UNITED STATES PATENT AND TRADEMARK OFFICE

10/042,177

Office Action Summary

FIG_2

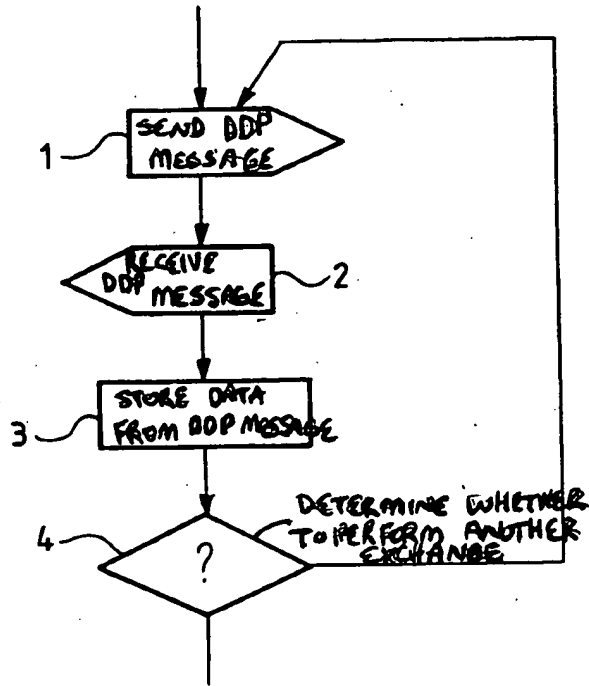
1. The drawings are objected to because the circle below "Hello Received" should have a descriptive label. Corrected drawing sheets in compliance with 37 CFR 1.121(d) are required in reply to the Office action to avoid abandonment of the application. Any amended replacement drawing sheet should include all of the figures appearing on the immediate prior version of the sheet, even if only one figure is being amended. The figure or figure number of an amended drawing should not be labeled as "amended." If a drawing figure is to be canceled, the appropriate figure must be removed from the replacement sheet, and where necessary, the remaining figures must be renumbered and appropriate changes made to the brief description of the several views of the drawings for consistency. Additional replacement sheets may be necessary to show the renumbering of the remaining figures. Each drawing sheet submitted after the filing date of an application must be labeled in the top margin as either "Replacement Sheet" or "New Sheet" pursuant to 37 CFR 1.121(d). If the changes are not accepted by the examiner, the applicant will be notified and informed of any required corrective action in the next Office action. The objection to the drawings will not be held in abeyance.
